Docket Item #6
BAR CASE# 2004-0201

BAR Meeting
October 27, 2004

ISSUE: Addition and alterations

LOCATION: 813 Oronoco Street

East elevation **Figure 1 - Front Elevation**

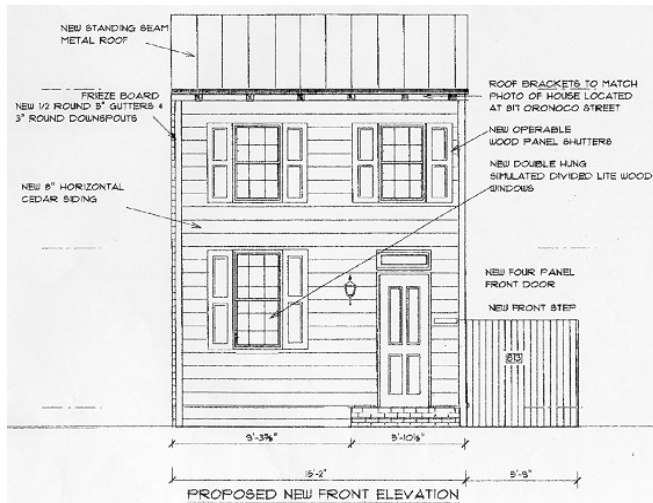
The existing rolled roof on the gabled main block will be replaced with a new standing seam metal roof. Half round gutters and round downspouts will be installed at the front of the house. The existing cement parged chimney in the center of the main block roof will be removed. A new cornice with paired brackets to match that at 817 Oronoco Street will be installed. The existing beaded lap wood siding on the front of the main block will be replaced by new 8" lapped

cedar siding. The existing siding is clearly old and may be original. The windows, which are modern replacement windows, will be replaced with new double hung simulated divided light windows in a six over six configuration. The dimensions of the windows on the second story in the front will be reduced by approximately 1' in length while those on the first story will remain the same. Operable wood paneled shutters will be installed on the front windows. The non-historic front storm and exterior door will be removed and replaced with a new four panel wood door. The drawings show the front door opening reduced in width by approximately 6". Staff assumes that this is an error. The single light transom above the door will either remain or be replaced in kind. Specification sheets provided by the applicant appear to be for a transom, indicating that it will be replaced, but the change is not shown on the drawings. A carriage style brass lamp will be installed to the left of the door. The existing concrete front stoop will be replaced with a new brick stoop similar to that at 817 Oronoco Street. The wood fence and gate to the right of the house at the front will remain.

The beaded lap siding on the front of the house is similar to that found on antebellum houses in the Old and Historic District and unless evidence is uncovered to indicate otherwise, Staff believes it is original to the building. Although somewhat rough due to paint build-up and weathering, a cursory investigation suggests that it is sound, except at the top where prolonged water infiltration has occurred. Therefore, Staff believes that, if at all possible, this siding should be retained. If replaced, it should be replaced with siding that matches the existing as closely as

Similarly, Staff believes that it would be a mistake to add a cornice matching the cornice at 817 Oronoco Street. The bracketed cornice is typical of the Italianate style. If added to the house at 813 Oronoco Street, the cornice would incorrectly link the house to the row of four and would suggest a later date of construction than may be appropriate. Therefore, Staff believes the cornice should be omitted altogether or a simple fascia board be used instead.

The center chimney is a characteristic of early residential construction in Alexandria. Therefore, Staff believes the chimney should be repaired and retained on the exterior, even if it is removed on the interior. Although the interior does not fall under the Board's purview, Staff notes that an original mantel remains in the front room on the first floor and encourages the applicant to retain this element in place or relocated to another wall as an item of architectural interest.

The standing seam roof should be a true standing seam rather than pre-fabricated.

A four panel door is shown on the drawing. This is a Victorian door type which is likely to be seen in conjunction with four over four or two over two windows. As the windows at the front of the house are to be six over six and the house is thought to be related more to Federal period than Victorian period, the front door should be a six panel door.

The front windows, which are readily accessible as the front of the house is at the sidewalk and the windows are at eye level, should have true divided lights rather than simulated divided lights. The *Design Guidelines* recommend the use of true divided light windows and limit the use of simulated divided light windows to elevations that have minimal visibility (Windows - Page 2).

If the Board should approve simulated divided light windows for the front of the house, Staff recommends that the windows have muntins no greater than 7/8" wide and that Staff approve the window selection before installation. The specification sheet the applicant provided indicates that the muntins will be 1" wide. Windows with muntins this wide have a clunky and inauthentic appearance.

It is not entirely clear from the materials submitted whether the transom over the front door is to be replaced. If it is, Staff recommends that it be replaced with a three light transom, which would be more compatible with the period of the building and configuration of the replacement

Figure 2 - East Side Elevation

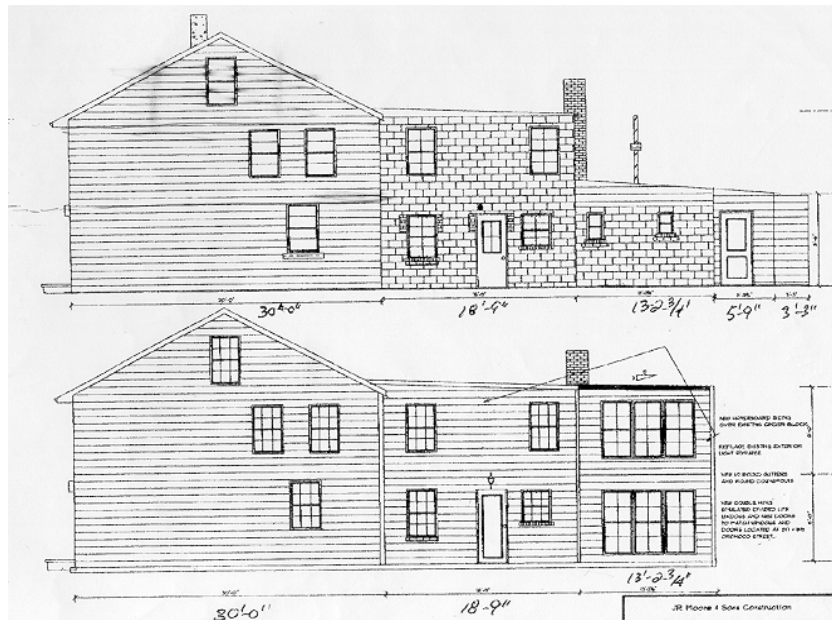
The east elevation of the main block is to remain as is, with the exception of the windows. Here, as elsewhere, the new windows will be double hung simulated divided light wood windows in a six over six configuration. The existing windows are not historic.

The two story cinderblock addition will be clad in 8" fiber cement siding. The existing metal windows will be replaced with new double hung simulated divided light wood windows in a six over six configuration. The existing door will be replaced with a new fully glazed door. The material of the door is not specified. A specification sheet provided by the applicant appears to indicate that it will be wood. A carriage style brass lamp will be installed above the door.

The one story cinderblock section will have new fenestration, consisting of a set of three long four over four wood windows with simulated divided lights. Fiber cement siding will cover the cinderblock.

The second story addition will have the same footprint as the existing one story cinderblock section. The new addition will continue the "flat" roof line of the existing second story addition.

It will be clad in fiber cement siding and will have a set of three long four over four windows matching those below.

Lastly, Staff recommends that windows in the two story cinder block section just beyond the historic main block be four over four rather than six over six, to differentiate this modern addition from historic building.

Figure 3 - Rear Elevation

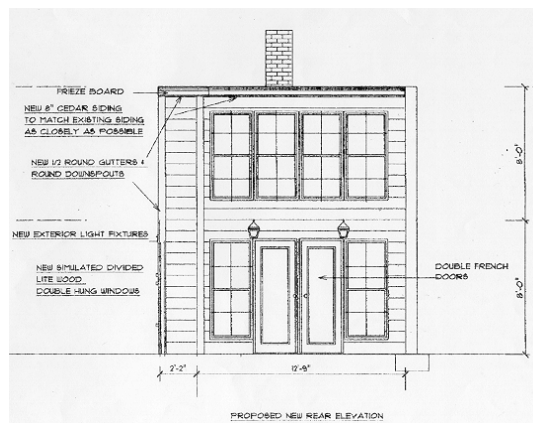
The rear elevation will be composed of the existing single story cement block section with the new second story addition above. There will be a pair of fully glazed doors flanked by long four over four double hung simulated divided light wood windows in the first story. The material of the door is not specified, but is assumed to be wood. Two carriage lamps will be located above the doorway. The new second story will have a set of four long four over four double hung wood windows. Half round gutters and round downspouts will be located on the rear elevation. An existing brick chimney at the back of the two story cinderblock section will remain in place and will appear above the new second story addition. The rear of the existing two story cinderblock section is approximately two feet wider than the rearmost section of the house and thus will be visible from the back. This narrow section of wall will be clad in fiber cement siding.
